REVIEWED ONLY AS TO GENERAL COMPLIANCE WITH THE INTENT OF THE GRADING AND SERVICING DRAWINGS. THE ENGINEER DOES NOT WARRANT THAT THE INFORMATION CONTAINED ON THIS PLAN IS EITHER ACCURATE OR CORRECT. SOLE RESPONSIBILITY FOR CORRECT DESIGN, DETAILS AND DIMENSIONS WILL REMAIN WITH THE PARTY SUBMITTING THE DRAWING

ROUNDEL HOMES INC. (PH-2)

LOT No. 57

PRAIRIE ROSE DRIVE

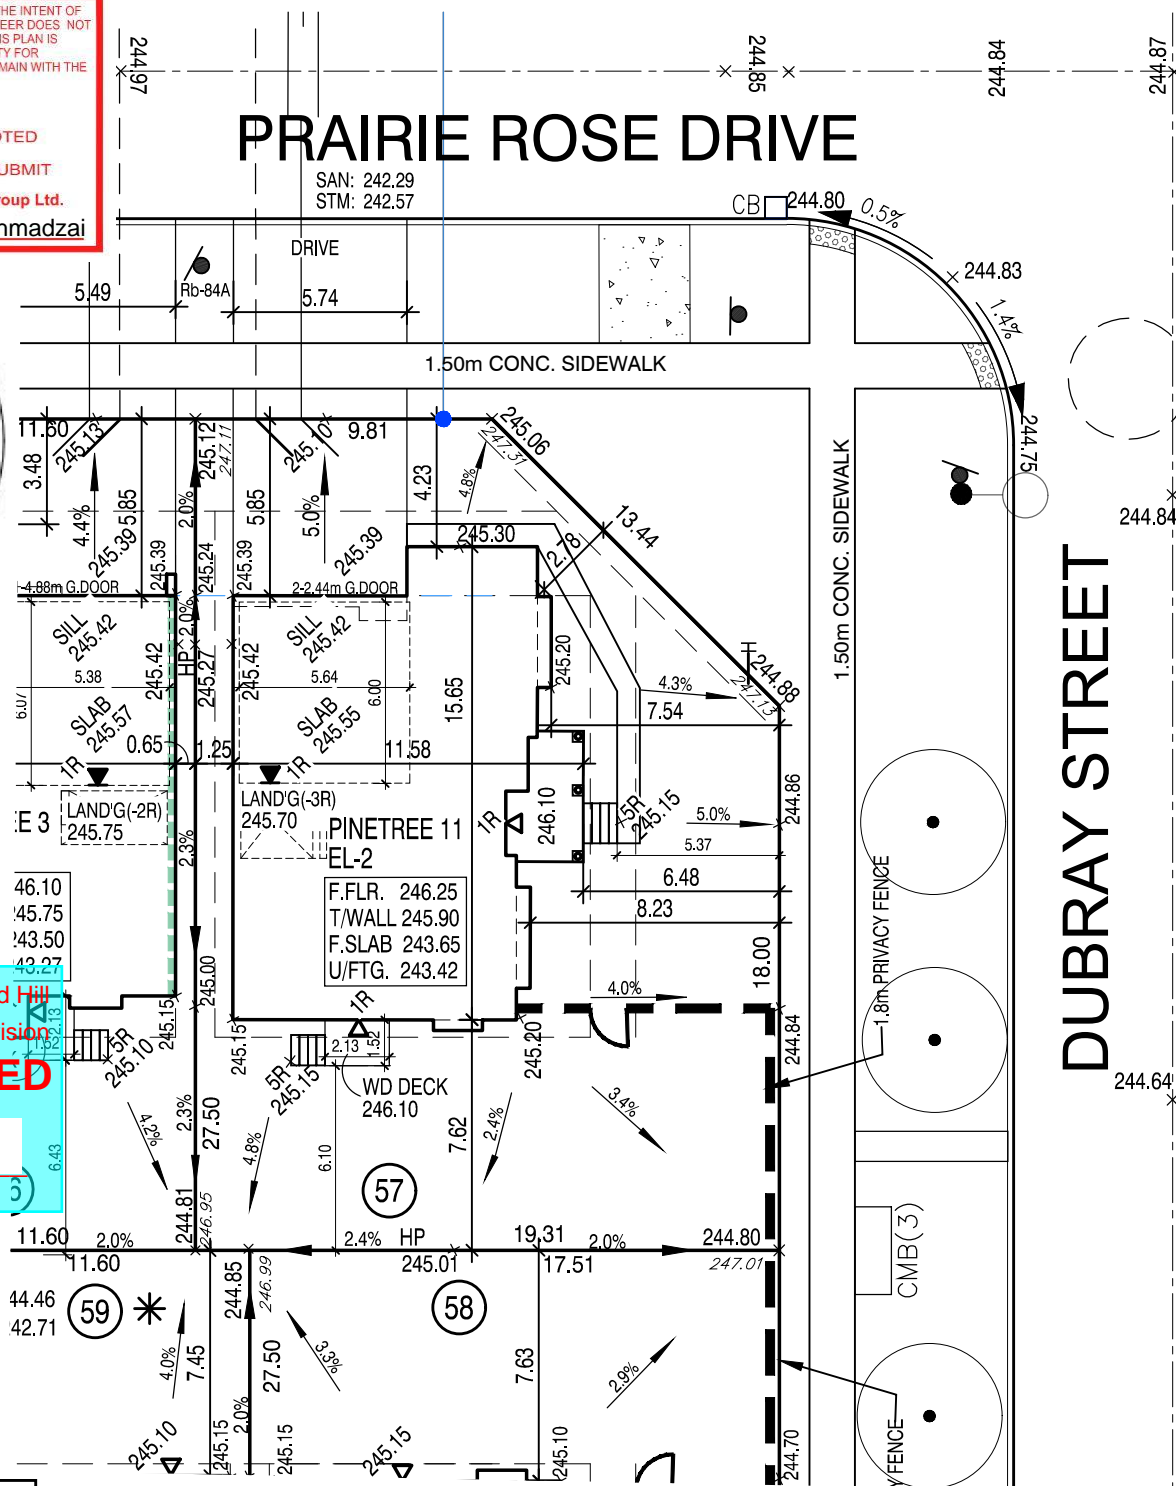
No unprotected openings permitted within 1.2 metres of the lot line as per 9.10.14 of the Ontario Building Code.

45 MINUTE RATED WALL WITH SIDE YARD < 1.2m
